Ref: 06S.VA0019

West Dublin 220/110 kV Substation and Associated Works
Response to submissions received by An Bord Pleanála

Project: West Dublin 220/110 kV Substation and Associated Works

Title: Response to submissions received by An Bord Pleanála

Title: **Proposed circuit route revision**

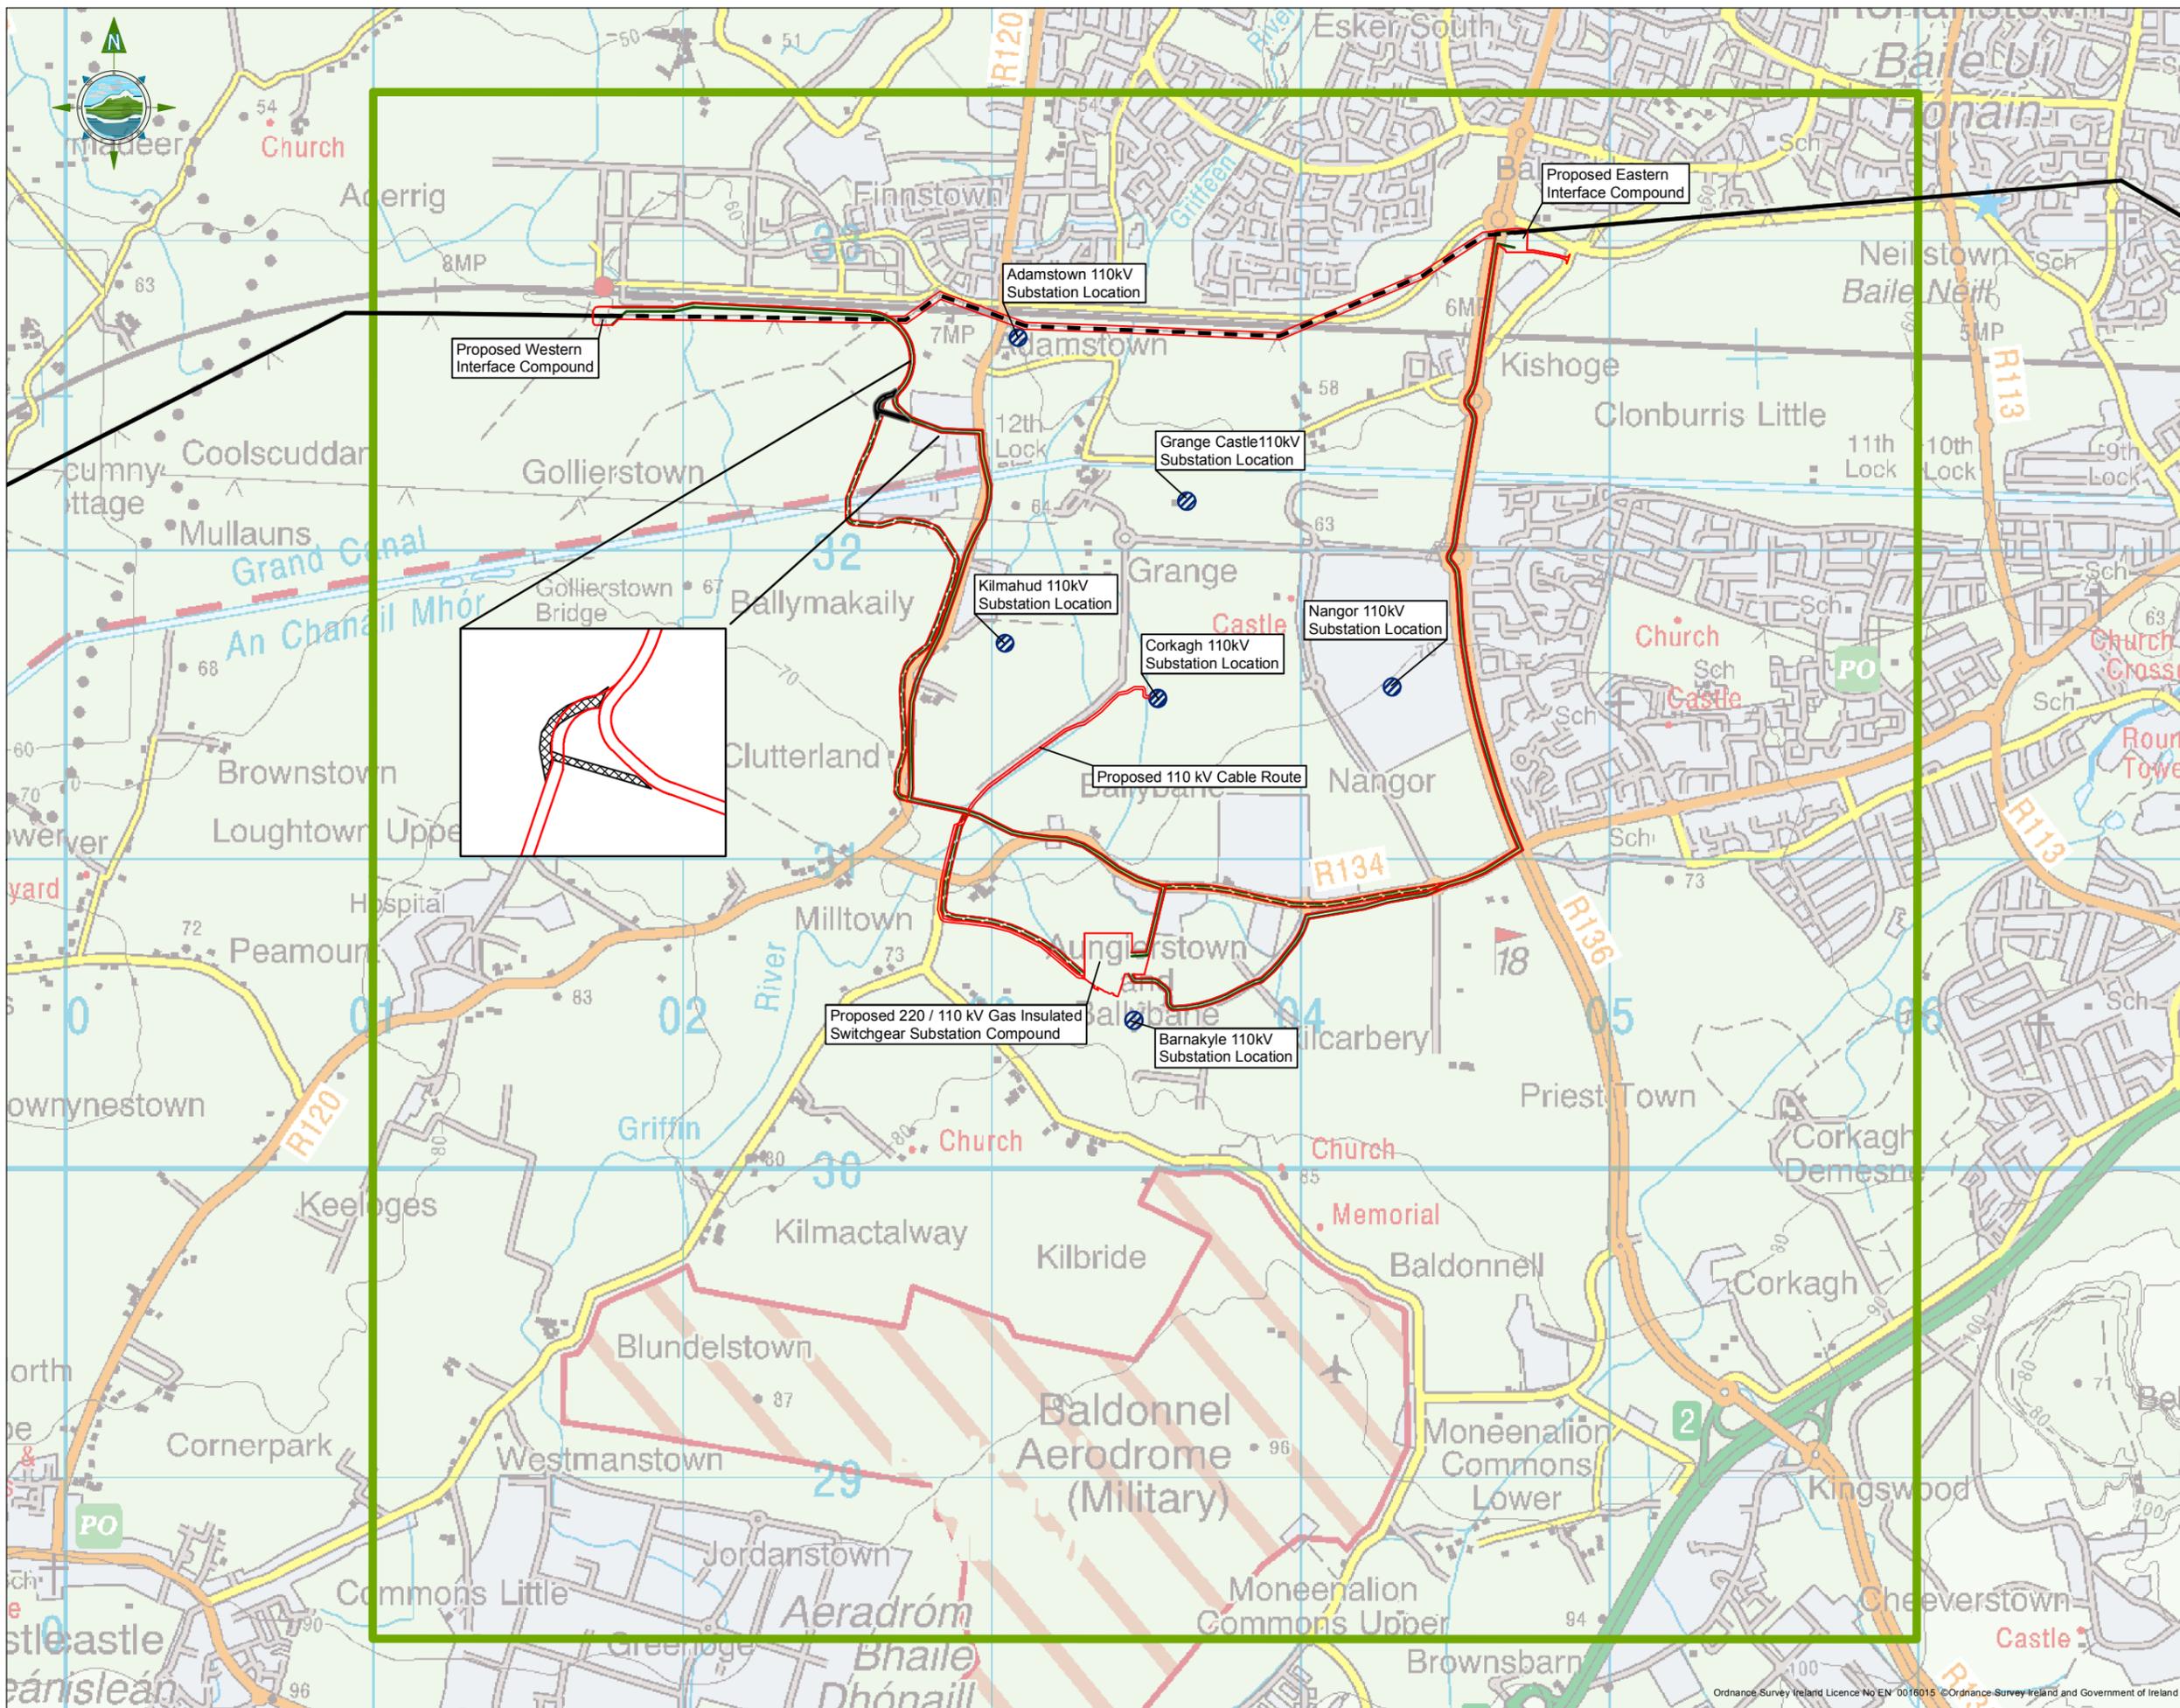
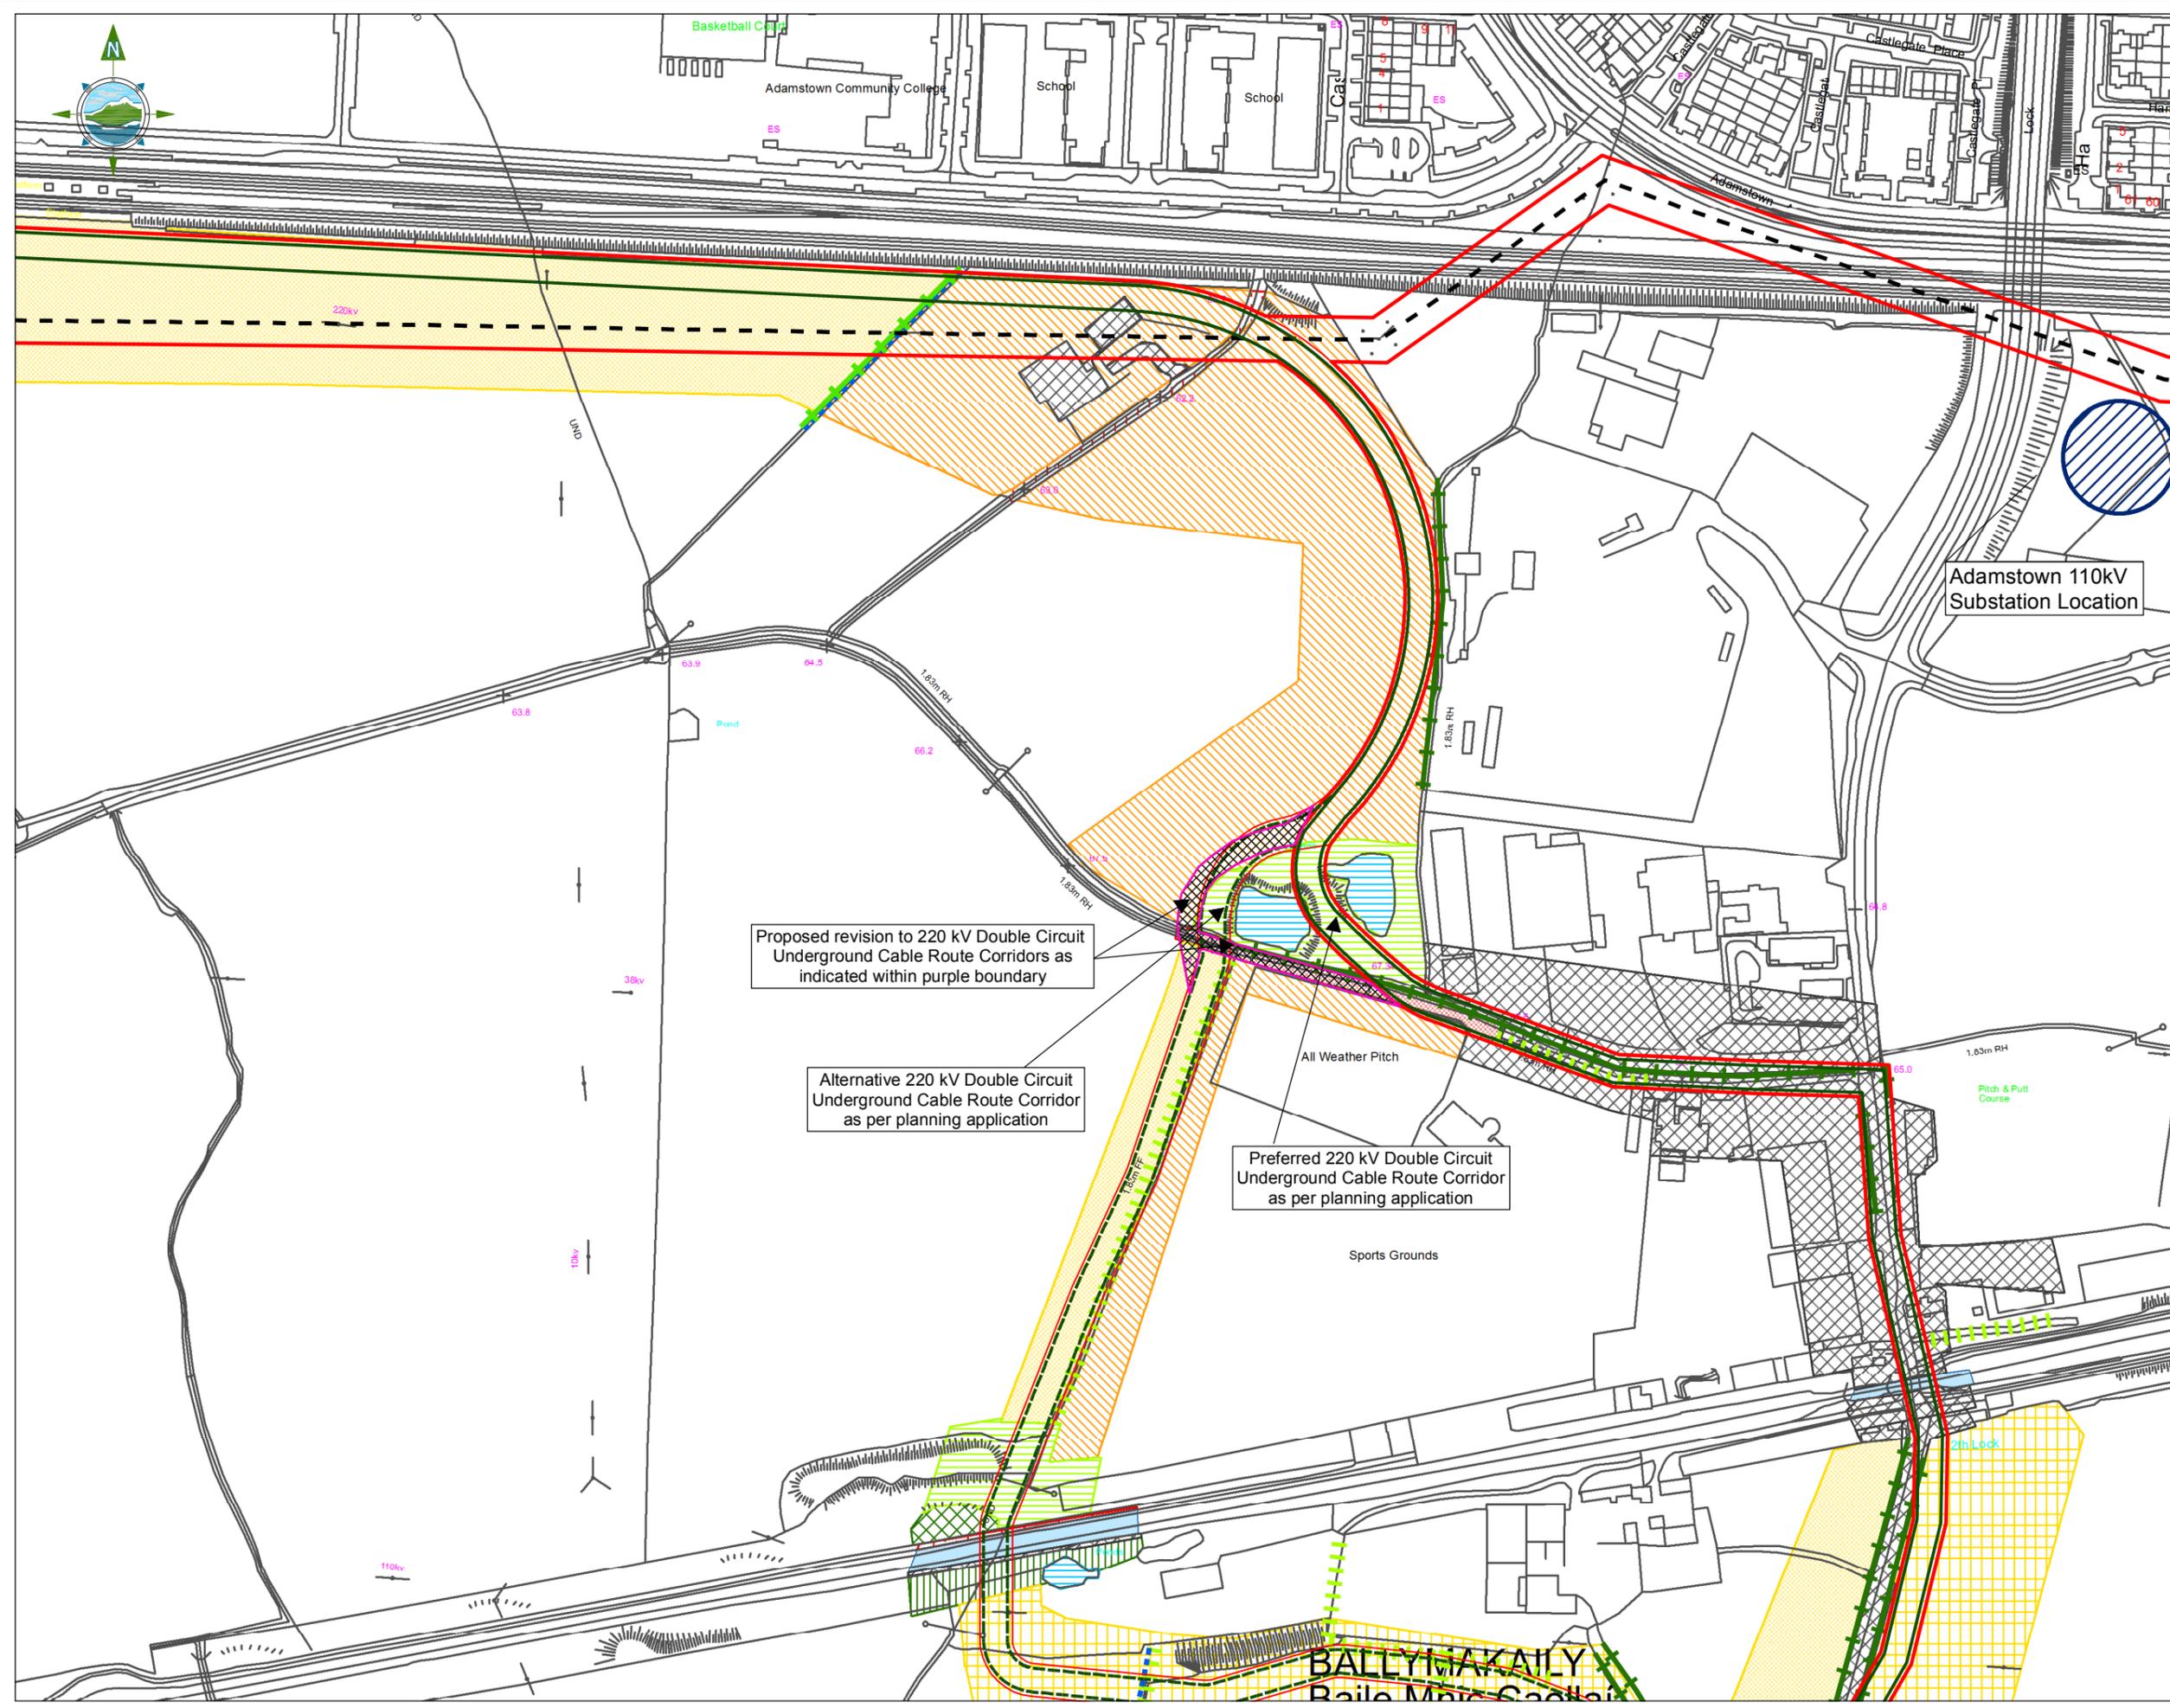
The submission notes a woodland area off the western side of the R120 which contains a pond area. The NPWS notes a high probability that smooth newts occur at the pond area and that this habitat is one of potential value.

Access for environmental surveys was not facilitated for the area of lands that include the western interface compound site and access route. As a consequence, no smooth newt survey was conducted in the pond area.

Given the recommendations of the NPWS, EirGrid has identified a minor revision to the preferred cable route (Cable Route Corridor Option A) in this area for the consideration of the Board. This minor revision is shown on Figures 1 and 2 (contained in Appendix 1), and involves the 220 kV cables running to the west of the woodland habitat – essentially in the corridor identified for alternative Cable Route Corridor Option B, with some provision made for an adequate cable bend radius -, and along the entire length of the existing private laneway adjacent to Lucan Sarsfields GAA club.

This modified route option would therefore not run through the woodland habitat, including the pond area. This minor revision to the proposed cable route would not result in significant or adverse effects on the environment.
